# Work Order ID 113972

Item Name: Crosstube Turning Detail

<b>DART AEROSPACE LTD</b>		<b>Work Order:</b>	113972
<b>Description:</b> Crosstube Assembly (205/212 High Aft)		<b>Part Number:</b>	D212-664-241
<b>Inspection Dwg:</b> D212-664-241 <b>Rev:</b> D		<b>Page 1 of 2</b>

DRAWING NO. D212-664-241	TITLE CROSSTUBE ASSY (205/212 HI AFT)	REV. D	<b>DART AEROSPACE LTD. ENGINEERING ORDER</b>		D.E.O. NO. D212-664-241-D-1	SHEET NO. SHEET 1 OF 2	SCALE NTS
DRAWN	CHECKED	MFG. APPR.	APPROVED	DE APPR.			
DATE 11.04.07	DATE 11.04.11	DATE 11.04.12	DATE 11/04/12	DATE 11.04.12

**D212-664-241/-241B  
ASSEMBLY DETAIL**

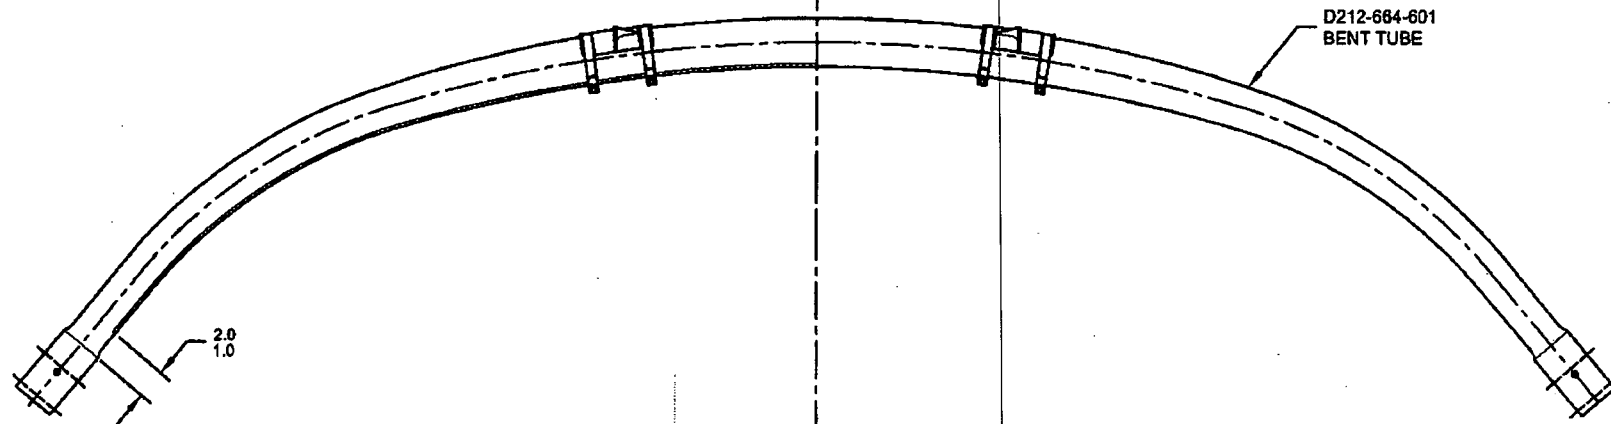
**PURPOSE:**

ADD AN INSPECTION WINDOW TO UNDERSIDE OF CROSSTUBE.

NOTES 2 OF SHEET 1 IS AMENDED AS FOLLOWS:

- 2) FINISH: CHEMICAL CONVERSION COAT PER DART QSI 005 4.1  
PRIME INSIDE AND OUTSIDE PER DART QSI 005 4.2  
MASK UNDERSIDE OF CROSSTUBE AS SHOWN (HATCHED AREA) AND  
PAINT OUTSIDE PER DART QSI 005 4.2  
REMOVE MASKING AND APPLY CLEAR COAT

MASK AREA PRIOR TO PAINTING,  
REMOVE MASKING AFTER PAINT  
AND APPLY CLEAR COAT
